Access Compliance Report

Public Rights-of-Way (Curb Ramps)

Intersection ID: N/A	Main Street: CITY_PARK_DR	Cross Street: N/A	Location: NW
ADA ID: F71D3D08235F	Ramp Type: BlendTrans1	Initial Pass/Fail: Pass	Overall Compliance: No
		Severity Score: 22.5

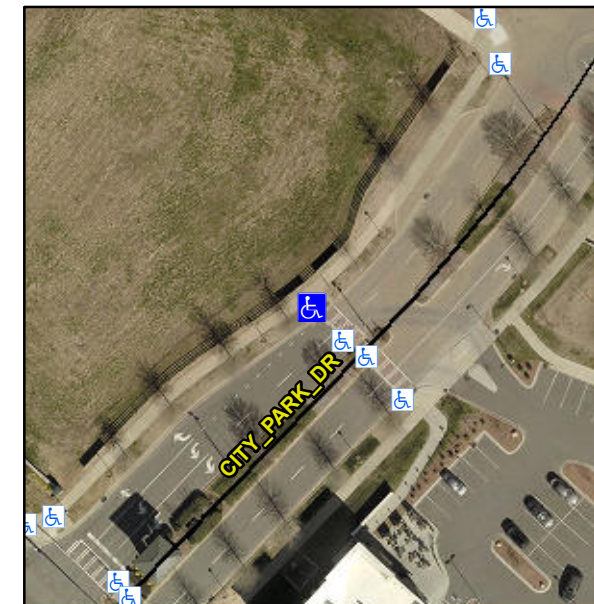
Not Found, R304.2.2-Perp, R304.3.2-Para, R305.1.4, R302.7.2, R304.5.4

Yes	Ramp inside XWalk1?	Yes	N/A	Ramp inside XWalk2?	N/A
	Road Slope (%)	1.2		Clear Space?	Yes
	Road X Slope (%)	4.1	N/A	Clear Space to XWalk (in)	N/A
Yes	Any Obstructions?	No	Yes	Storm Grate/Utility Hazard?	No
	Obstruction Type			Storm Grate/Utility Type	
		N/A			N/A
			Yes	Surface Condition? (G/P)	Good
			No	Curb Slope (%)	8.5

Remove & Replace Curb Ramp With Two New Directional Ramps or Equivalent. Remove & Replace Gutter.
